CITY OF GRAND HAVEN
GRAND HAVEN, MICHIGAN
PLANNING COMMISSION
MEETING AGENDA
September 15, 2026

DATE: September 11, 2026
TO: Grand Haven Planning Commission
FROM: Brian Urquhart, City Planner
RE: Case 26-29: 700 Robbins Rd. Site Plan

DATE: September 11, 2026
TO: City of Grand Haven Planning Commission
FROM: Brian Urquhart, City Planner
RE: 601 S. Beechtree Site Plan

DATE: September 10, 2026
TO: City of Grand Haven Planning Commission
FROM: Brian Urquhart, City Planner
RE: 224 Washington Ave. (former Jewelry building)

D EAST ELEVATION
A4 1/8" = 1'-0"

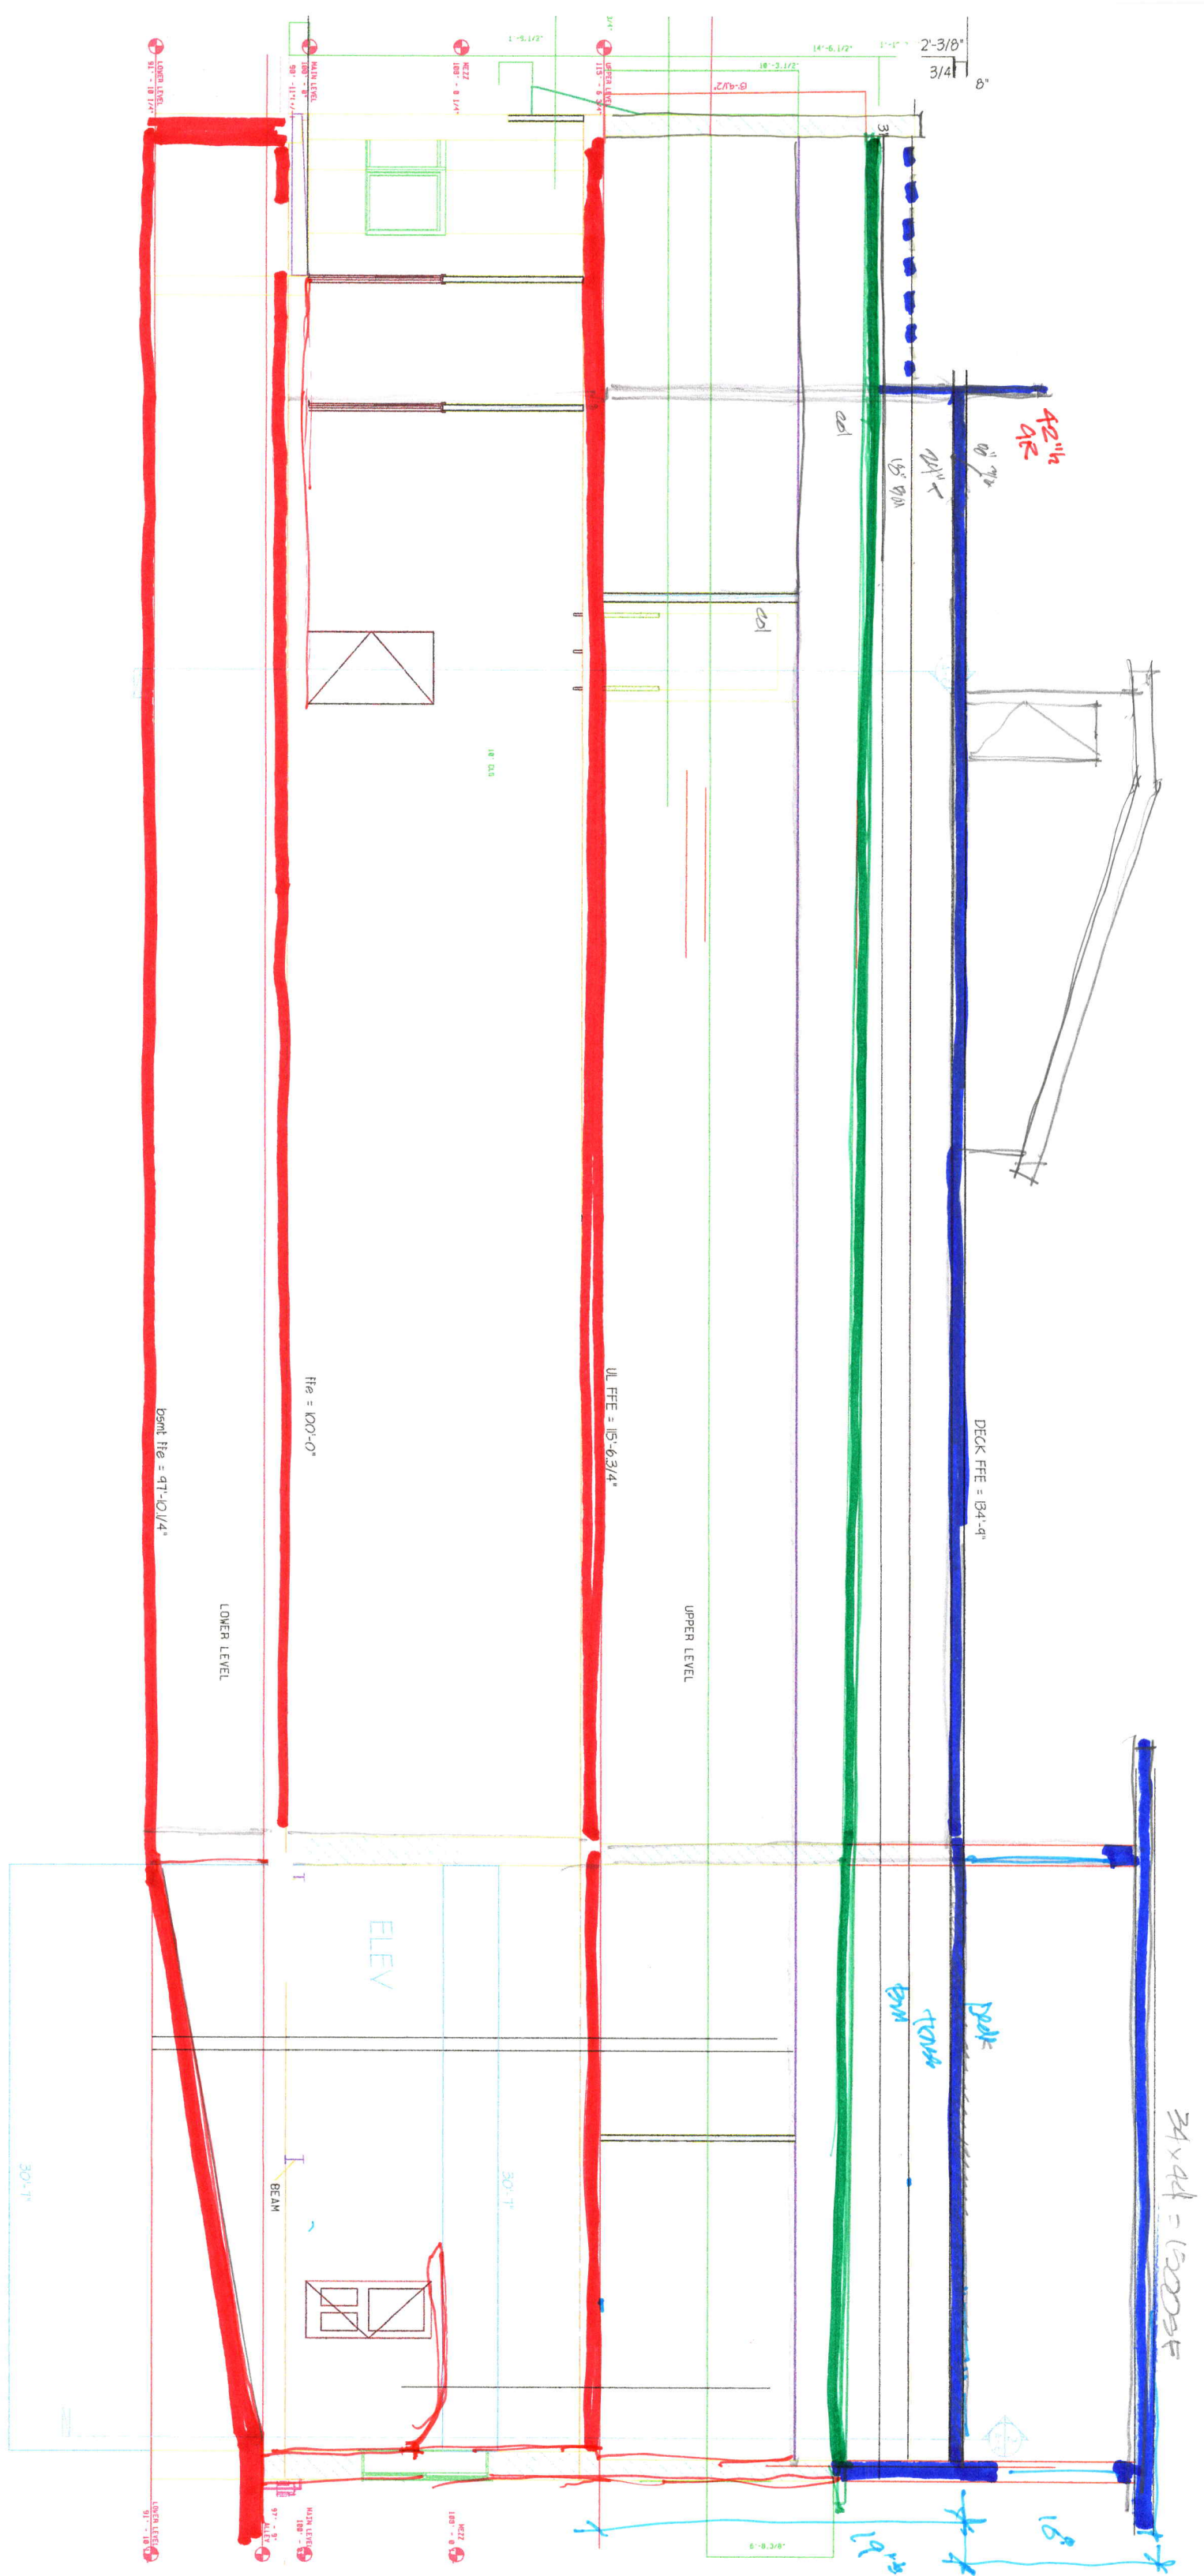
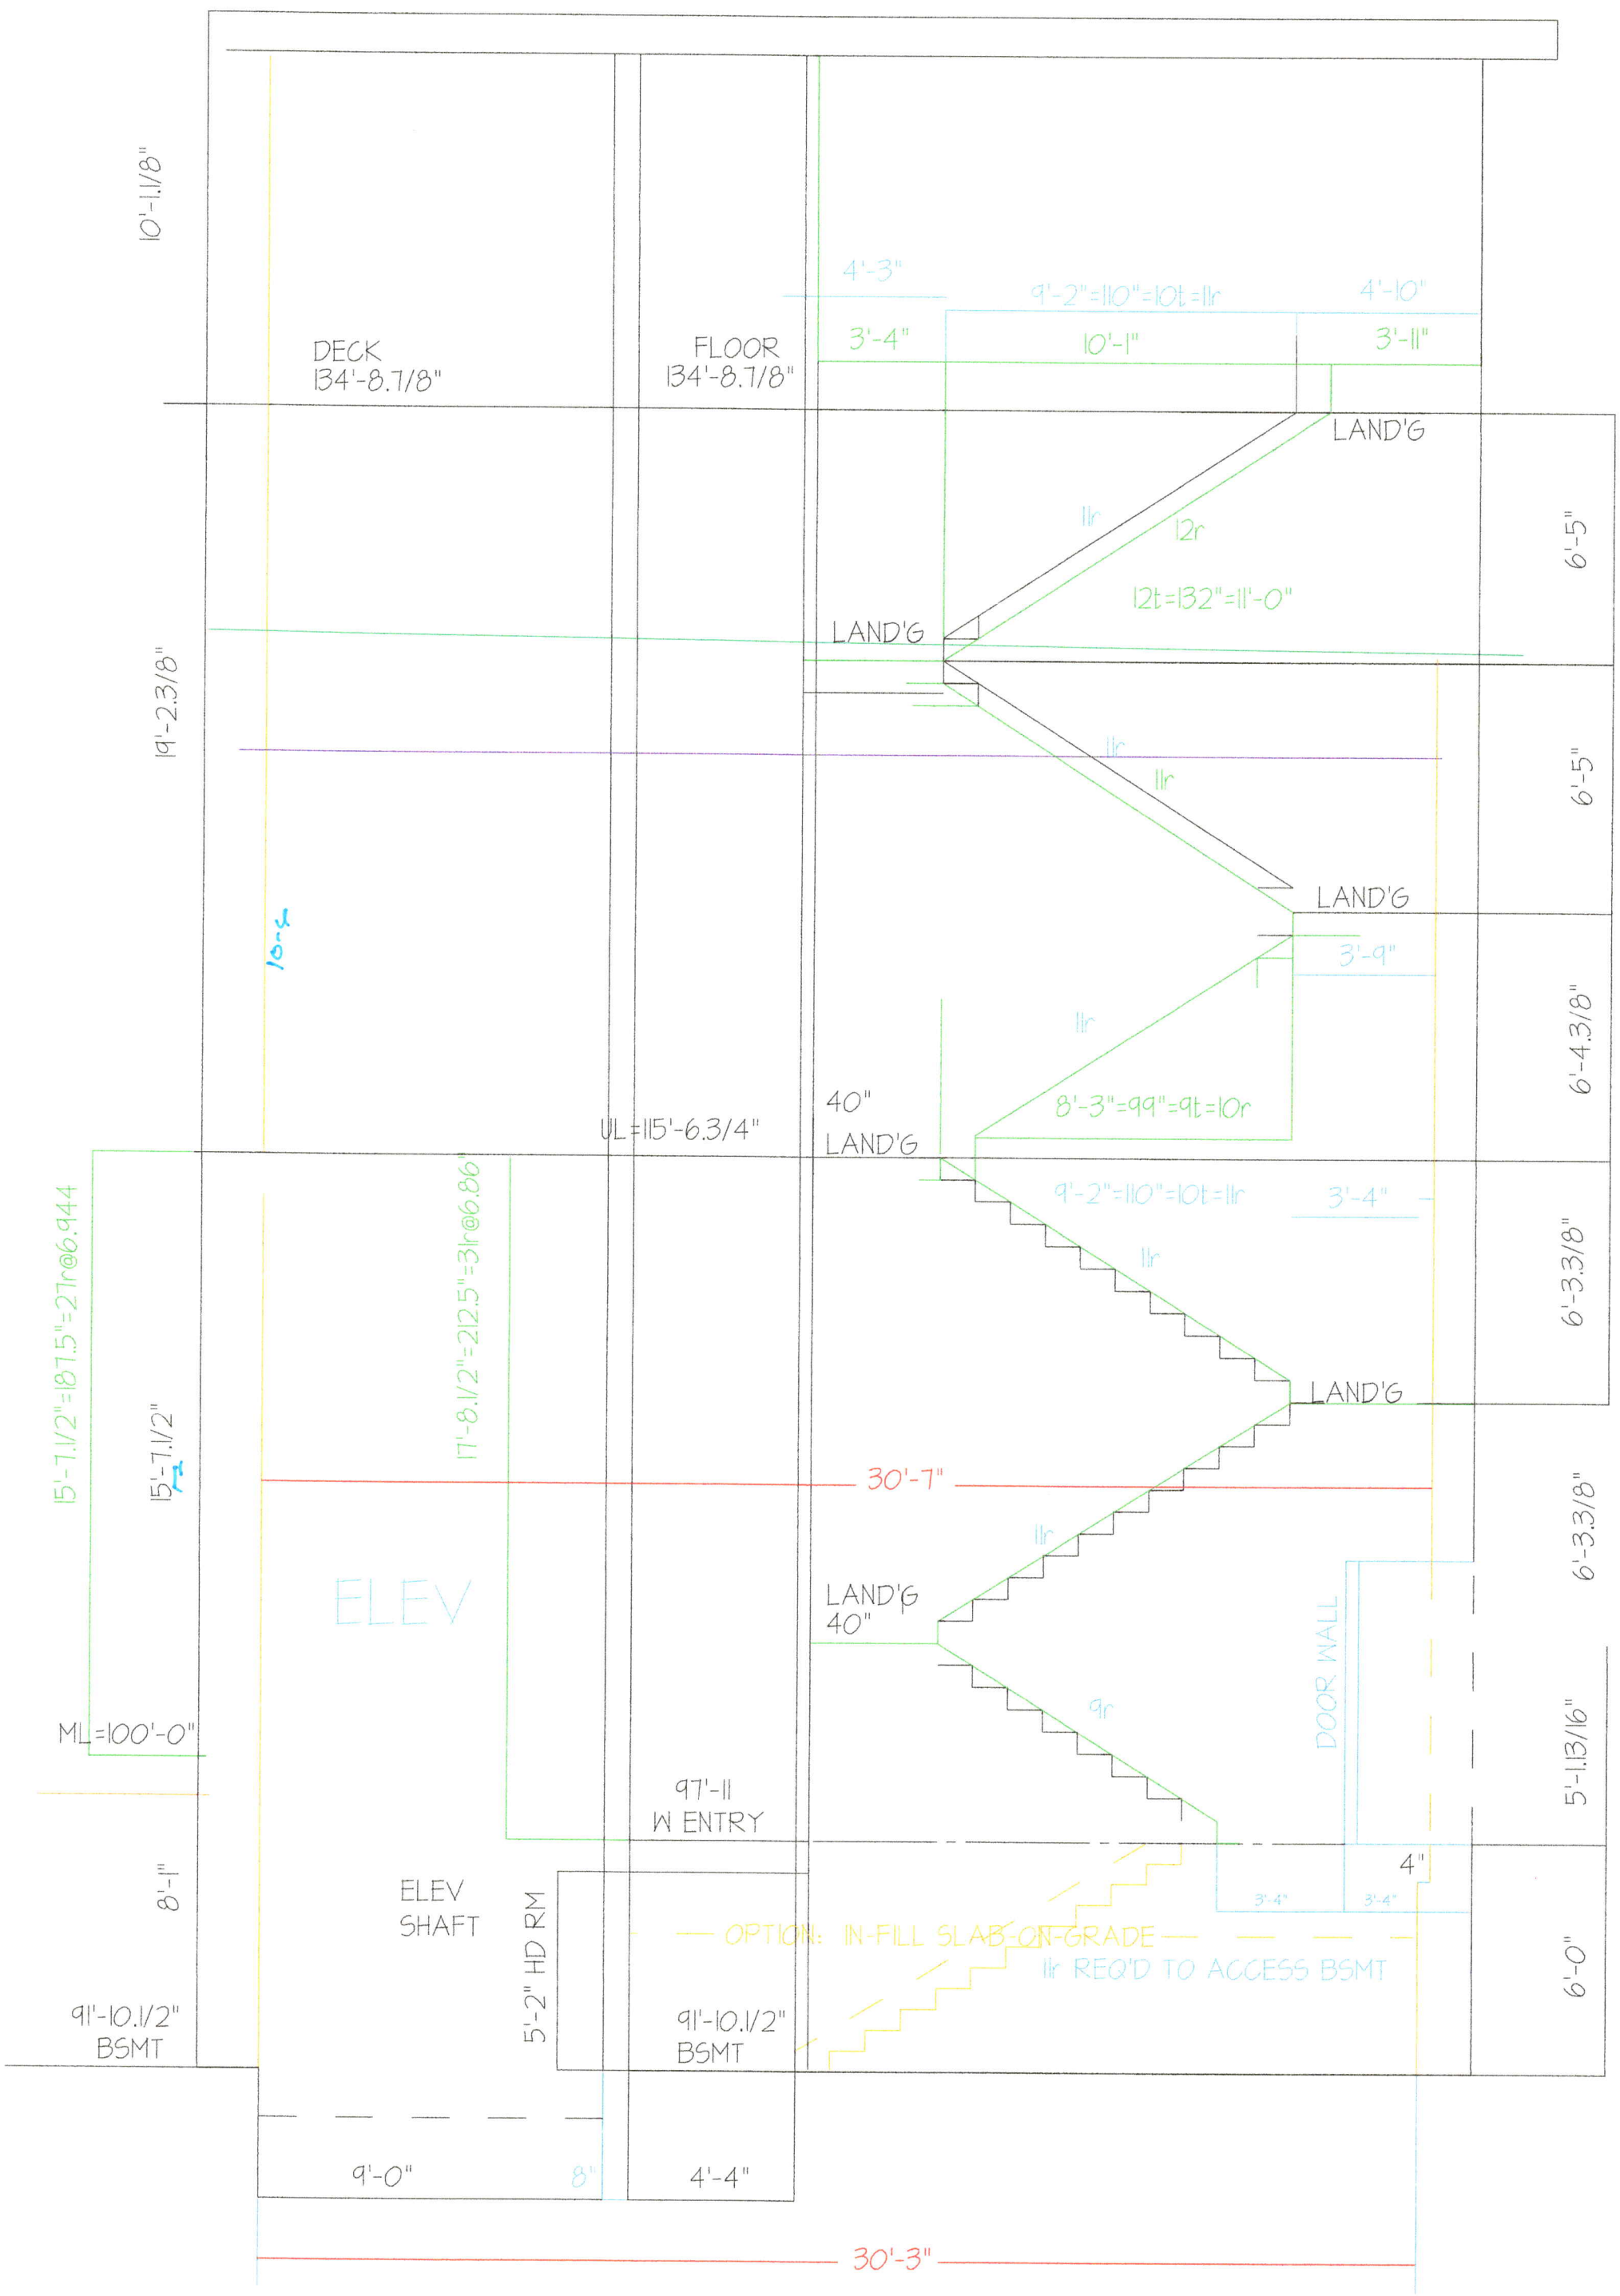
The north elevation is proposed to remove the awning and install large windows that would run floor to ceiling, increasing the transparency of the primary wall. The upper-level windows will be replaced. The south elevation of the building is shown to include new windows, entrance, garage door, and possible balconies off the 2nd level. No other exterior building changes are proposed.
